Work Order ID 134798

Item Name: Fwd Crosstube - High 206 A/B

DRAWING NO. D206-667-141	TITLE CROSSTUBE ASS'Y (206B HIGH FWD)	REV. C	DART AEROSPACE LTD ENGINEERING ORDER		D.E.O. NO. D206-667-141-C-1	SHEET NO. SHEET 1 OF 1	SCALE NTS
DRAWN <i>Q</i>	CHECKED <i>ASS</i>	MFG. APPR. <i>[Signature]</i>	APPROVED <i>[Signature]</i>		DE APPR. <i>[Signature]</i>		
DATE 11.07.15	DATE 11.07.20	DATE 11.07.21	DATE 11/07/21		DATE 11.07.21

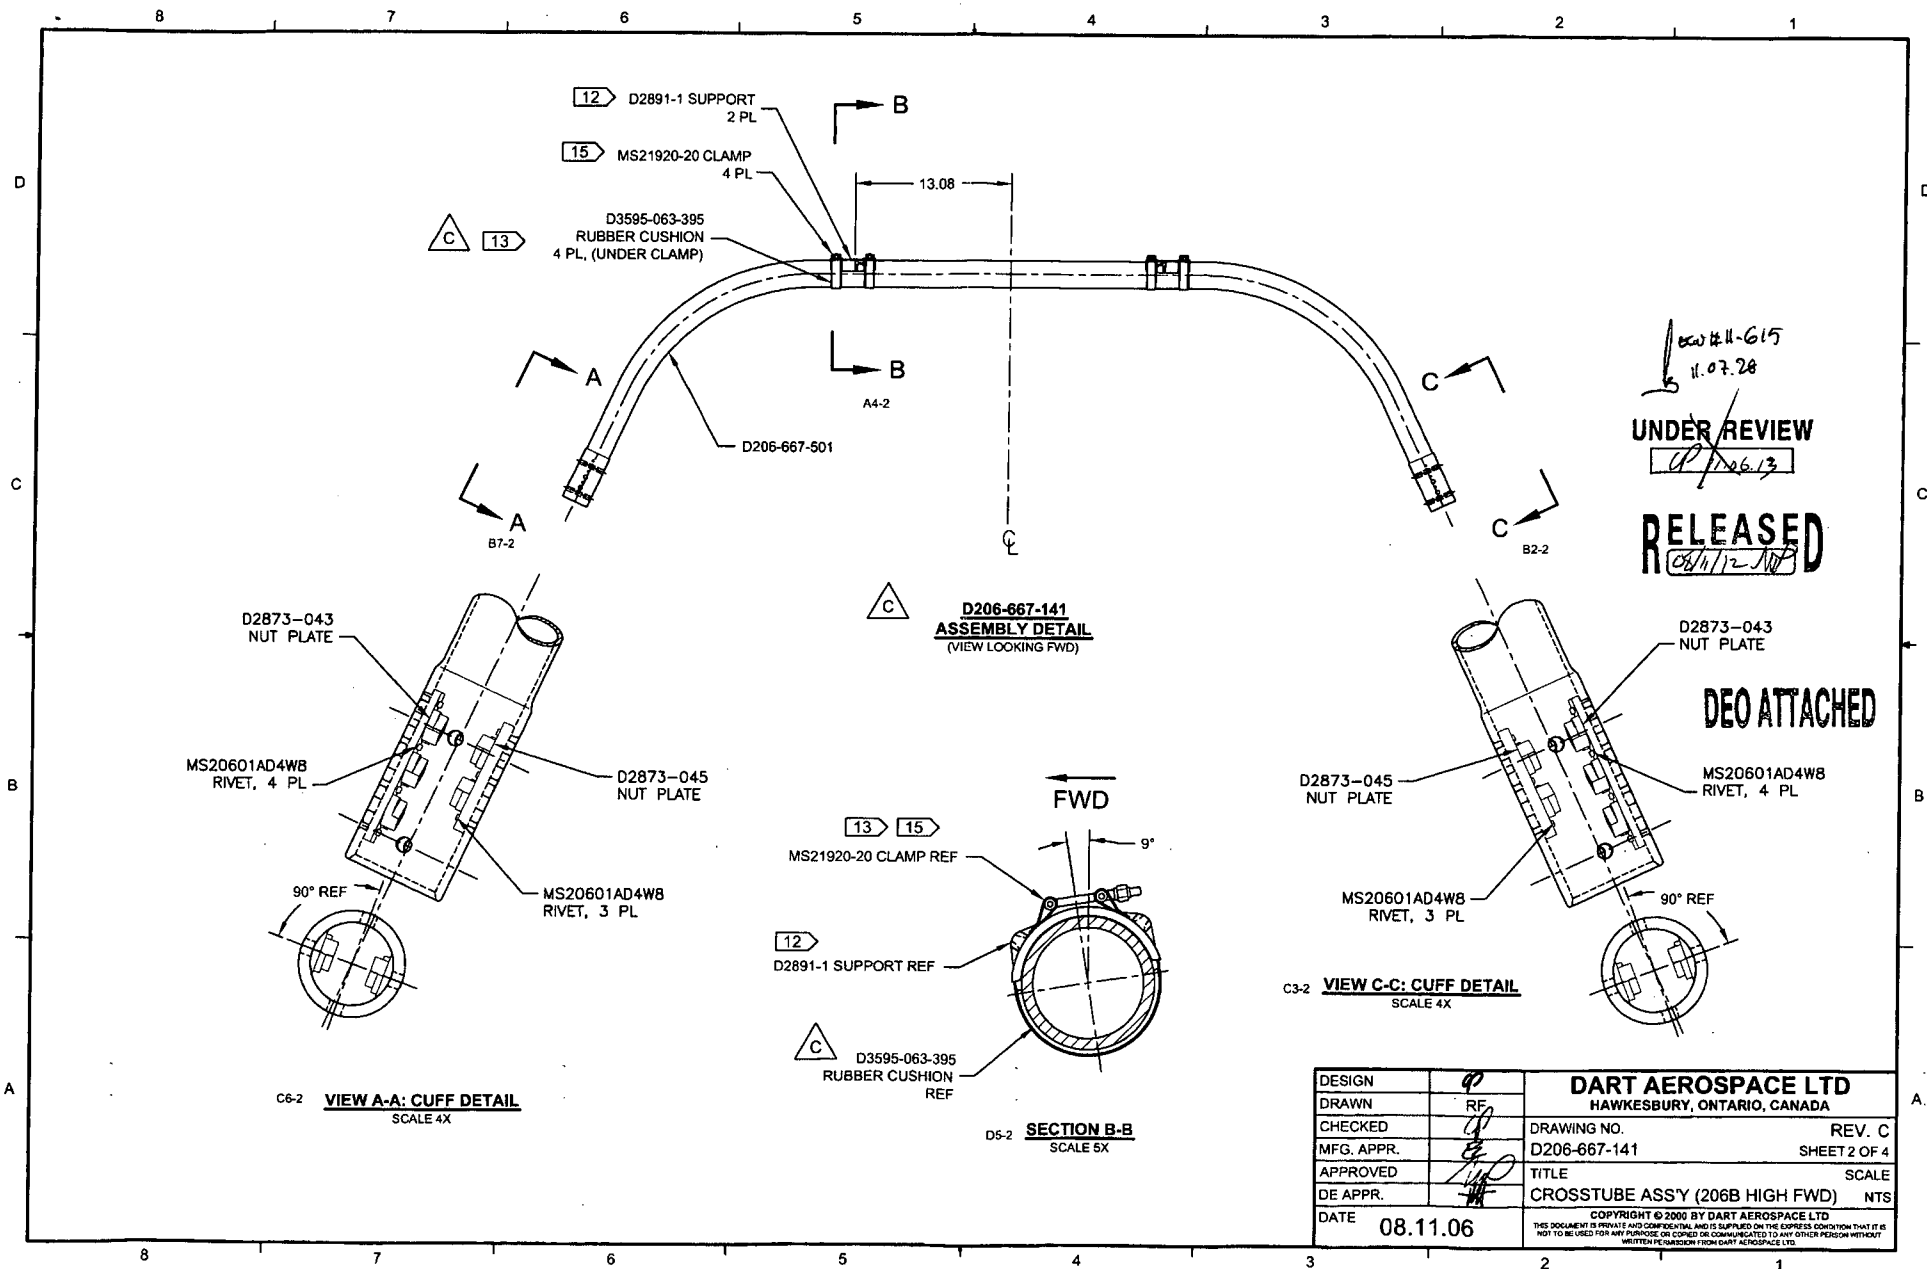
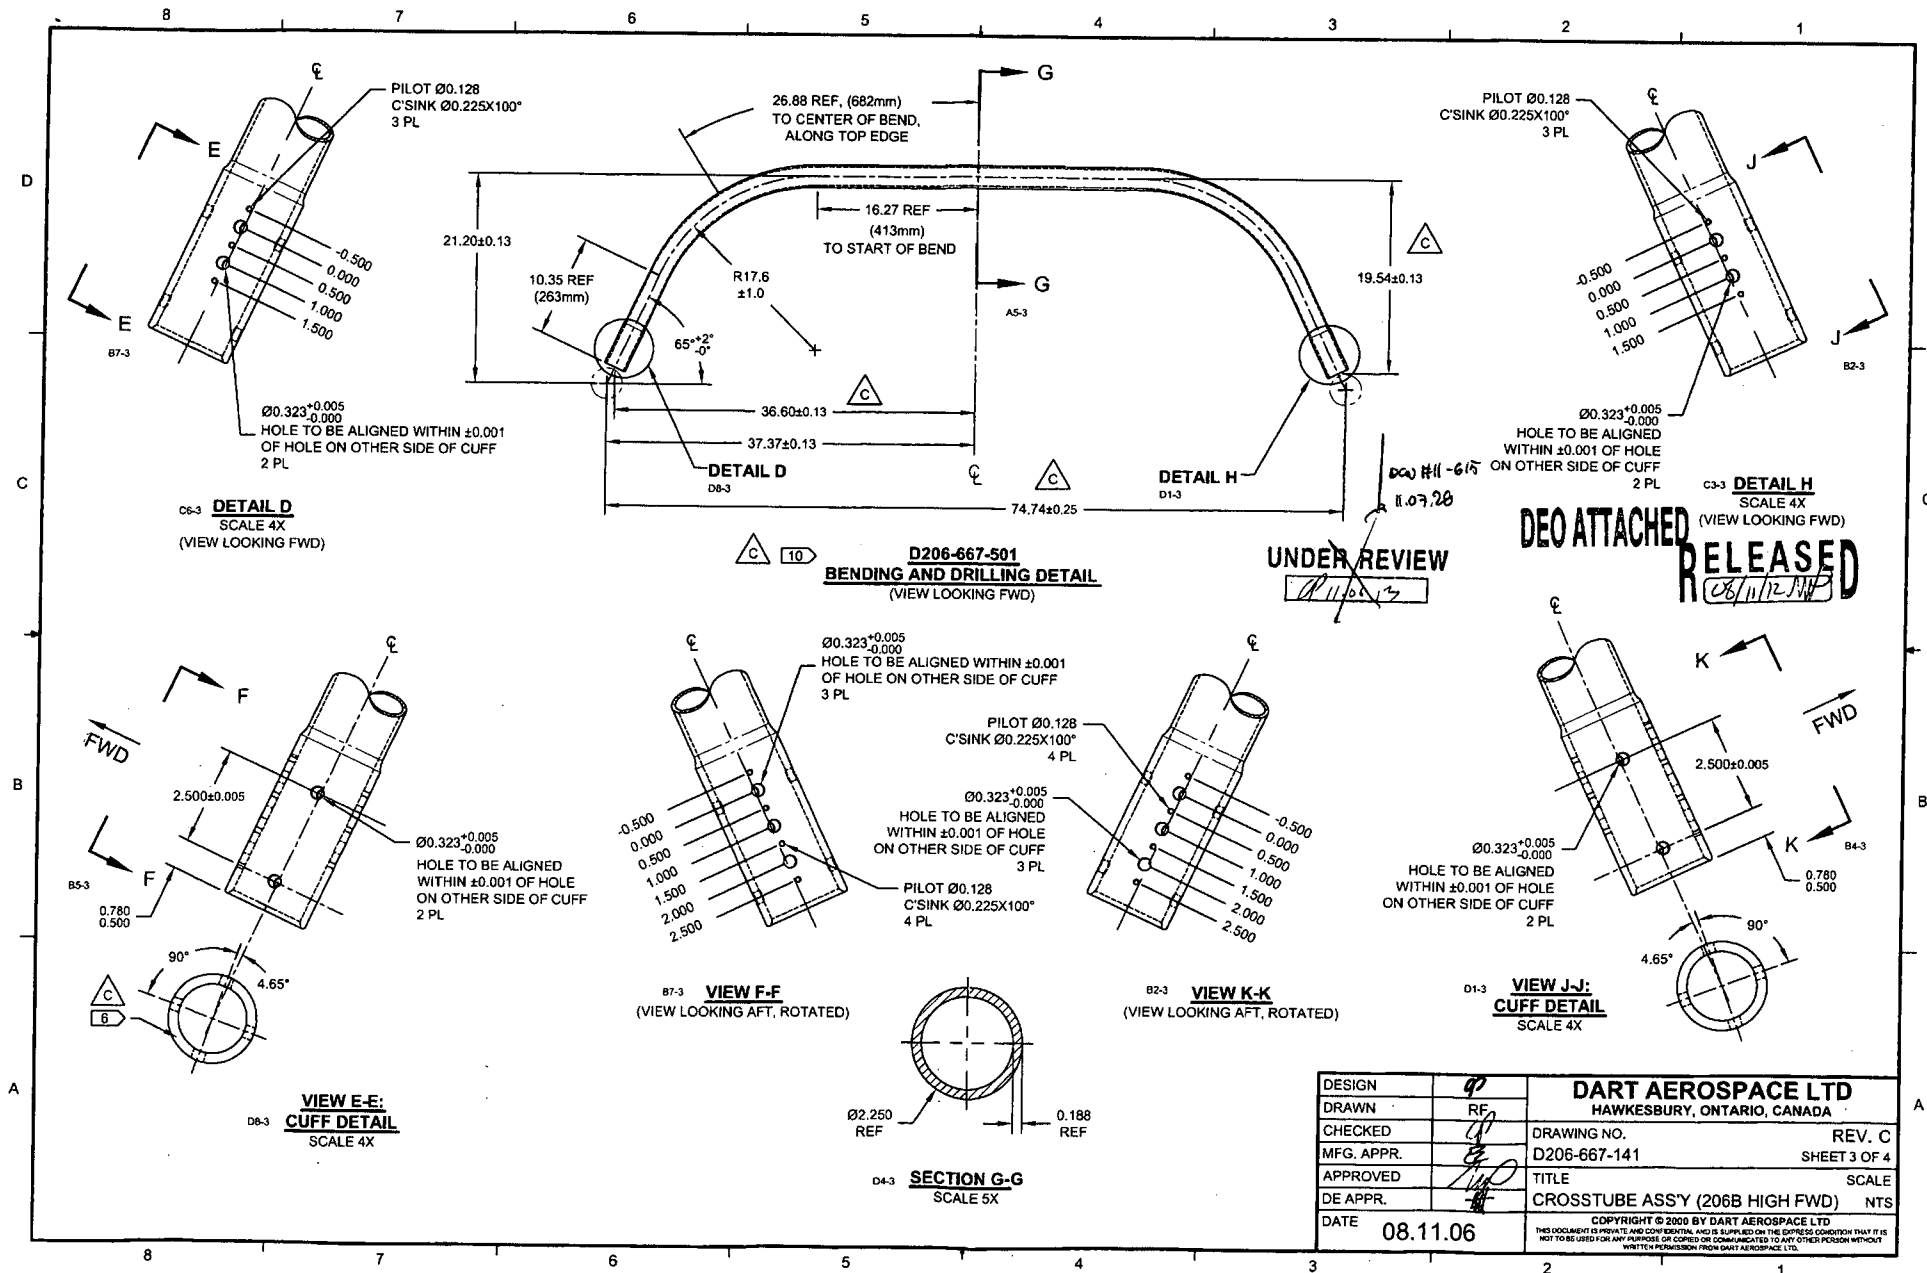
C	REVISE GENERAL NOTES/PART LIST (ZN D7-1); REORGANIZED VIEWS AND REFORMATTED DRAWING TO CURRENT STANDARDS. D3595-063-395 WAS D2856-400-694 (ZN D6-2 & A5-2); REMOVED REF. & ADD TOLERANCES (ZN C4-3, C5-3 & D3-3); RELOCATED FLAG #6 (ZN A8-3) PER NCR 210; MOVED TURNING DETAIL & UPDATED TOLERANCE TO SHEET 4.	RF	08.11.06
B	ADD HOLES AND NUT PLATES FOR COMPATABILITY WITH BHT/AA SKUDTUBES	PH	05.07.26
A	NEW ISSUE	CP	00.11.17
REV.	DESCRIPTION	BY	DATE
DESIGN	RF	DART AEROSPACE LTD HAWKESBURY, ONTARIO, CANADA	
DRAWN	RF	DRAWING NO.	REV. C
CHECKED	RF	D206-667-141	SHEET 1 OF 4
MFG. APPR.	RF	TITLE	SCALE
APPROVED	RF	CROSSTUBE ASSY (206B HIGH FWD)	NTS
DE APPR.	RF	COPYRIGHT © 2008 BY DART AEROSPACE LTD THIS DOCUMENT IS PRIVATE AND CONFIDENTIAL AND IS SUPPLIED ON THE EXPRESS CONDITION THAT IT IS NOT TO BE USED FOR ANY PURPOSE OR COPIED OR COMMUNICATED TO ANY OTHER PERSON WITHOUT WRITTEN PERMISSION FROM DART AEROSPACE LTD.

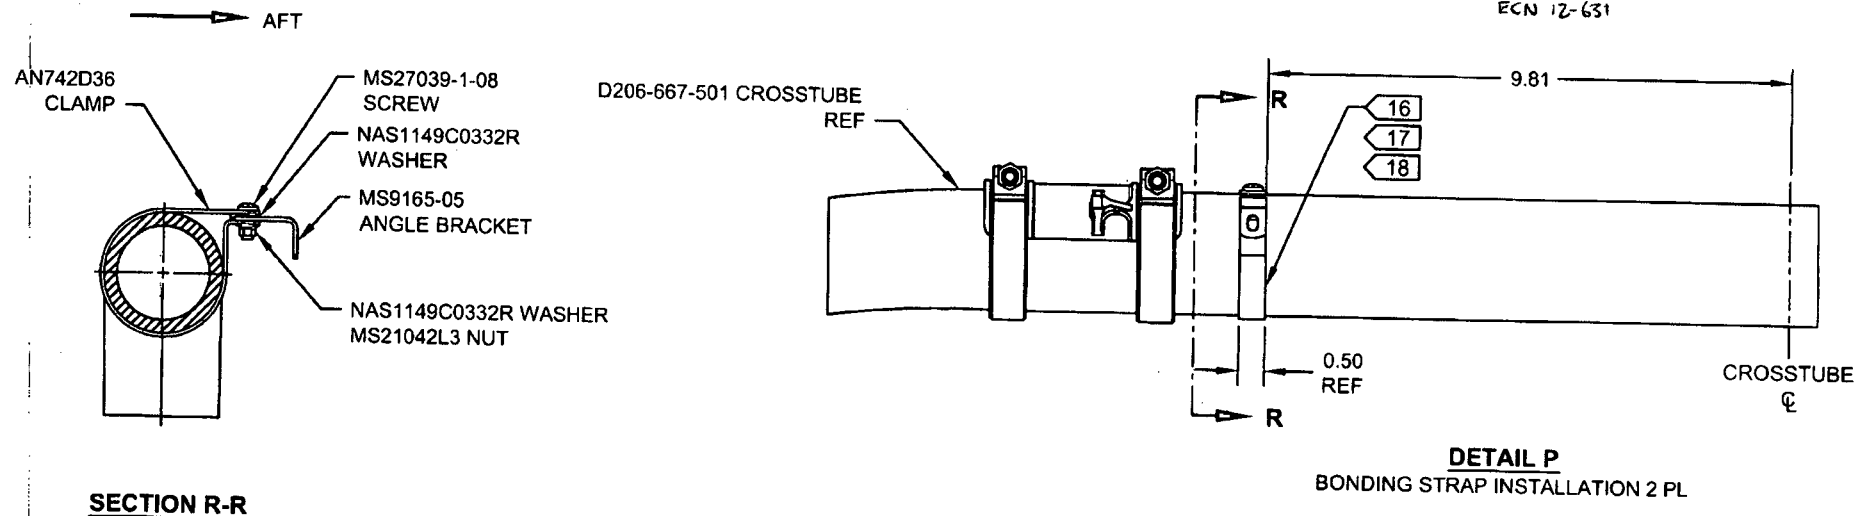
ADD ELECTRICAL GROUNDING STRAP

ITEM	QTY -141	PART NUMBER	DESCRIPTION	
1	X	D206-667-141	CROSSTUBE ASSEMBLY (206B HIGH FWD)	
10	2	AN742D36	CLAMP	} ADD
11	2	MS9165-05	ANGLE BRACKET	
12	2	MS21042L3	NUT (OR MS21042-3)	
13	2	MS27039-1-08	SCREW	
14	4	NAS1149C0332R	WASHER (OR AN960C10L)

- 16) MASK AREA UNDER CLAMP PRIOR TO PAINTING
- 17) SEAL EDGES WHERE AN742D36 CLAMP MEETS WITH THE CROSSTUBE USING SIKAFLEX-241/-291 OR MIL-S-8802 CLASS B2 OR PROSEAL 890 SEALANT
- 18) PERFORM RESISTANCE CHECK TO ENSURE MAX RESISTANCE IS 10 MILLIOHMS
